MODIFICATION INSTRUCTION

Bulletin Nbr: 291-2217 utg. 2

Replacement of check valve and banjo screw to remedy blue smoke

Emissions-related campaign 10719

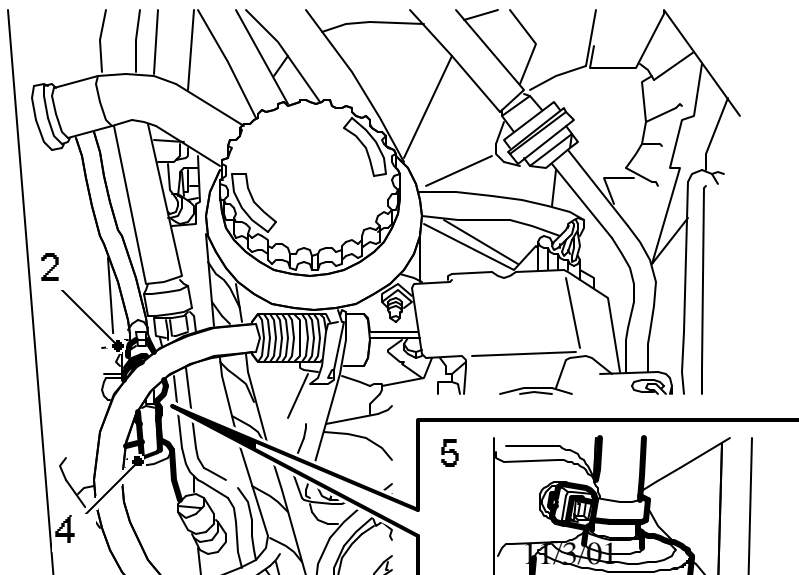
1. Remove the engine cover.

2. Cut off the cable tie securing the check valve to the camshaft cover.
3. Detach the vacuum hose from the camshaft cover and the throttle body.
4. Transfer the insulation hose from the old hose to the new.
5. Attach the new hose to the camshaft cover nipple and to the throttle body.

The check valve must be turned so that the flow is directed away from the camshaft cover towards the throttle body, see the arrow on the check valve.

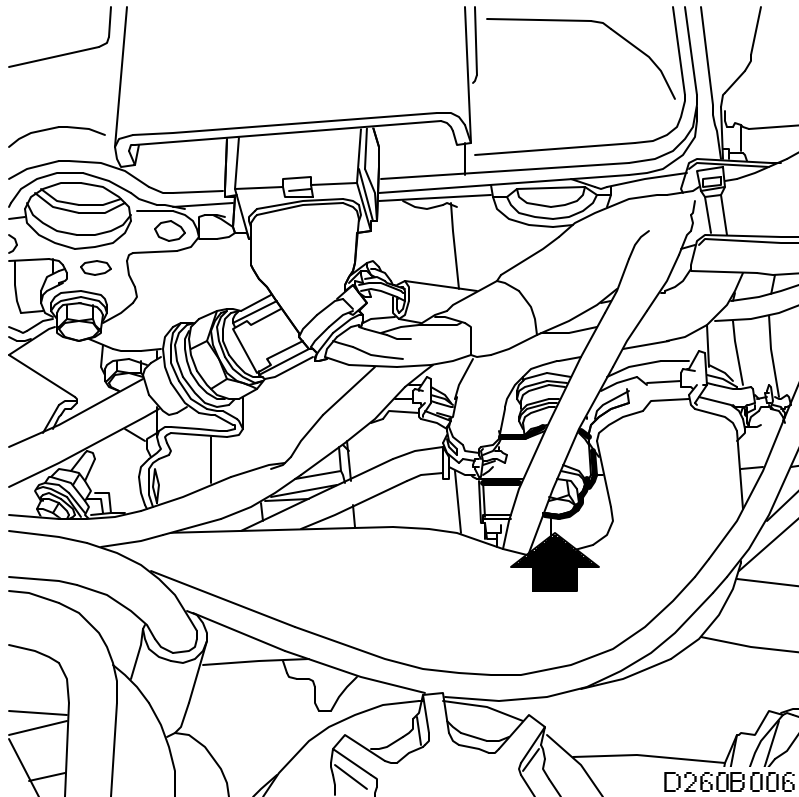
14. Place a receptacle under the car.
15. Using a fixed spanner to hold the coolant pipe nipple in place on the cylinder head, detach the coolant pipe from the cylinder head, see illustration, and the pressure sensor mounting.

16. Check that the coolant pipe nipple on the cylinder head is tightened, and fit the coolant pipe with a new banjo screw and new gaskets in the cylinder head, see illustration. Fasten the pipe to the pressure sensor mounting.

Banjo screw 51 25 406 must not be fitted anywhere else on the cooling system other than on the cylinder head connection.

Nipple in cylinder head 35 Nm (25.8 lbf ft)

Banjo screw, cylinder head 25 Nm (18.4 lbf ft)
